Queenstown Lakes District Council
Private Bag 50072
Queenstown 9348
New Zealand

9 June 2023

Northlake Private Plan Change 54 Stormwater Review

Figure 2: Proposed PC54 stormwater management system

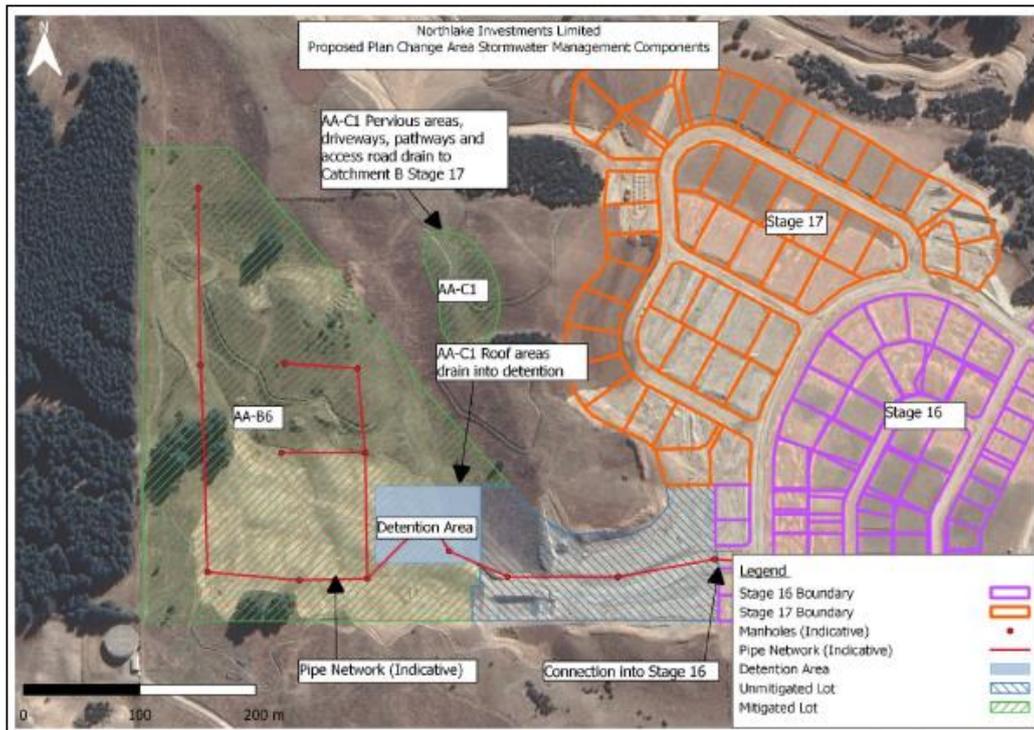
28. The proposed stormwater system would not address the increase in peak flow discharged in events smaller than the 10-year event. This means that it may increase the risk of downstream flooding in events smaller than the 10-year event (e.g. the 2-year and 5-year event). It would also not address the potential cumulative effects downstream from several detention ponds in multiple developments or stages of development.

29. The proposed stormwater management system would not address the increase in runoff frequency or increase in runoff volume from development in the PC54 area. This means that it would not mitigate the risk of downstream erosion caused by development in the PC54 area.

39. I therefore recommend that the proposed PC54 provisions are modified to include the following requirements:
 - a. To mitigate downstream flood risk, peak flow attenuation to limit post-development peak flow to 80% of pre-development peak flow for the 2-year, 5-year, 10-year, 20-year and 100-year events.

- b. To mitigate downstream erosion:
 - a. Retention or volume reduction of at least 5 mm runoff depth in any storm, plus
 - b. Extended detention storage draining down over 24 hours, for the difference between the pre- and post-development runoff volumes from the 95th percentile 24-hour rainfall event minus the 5 mm retention.
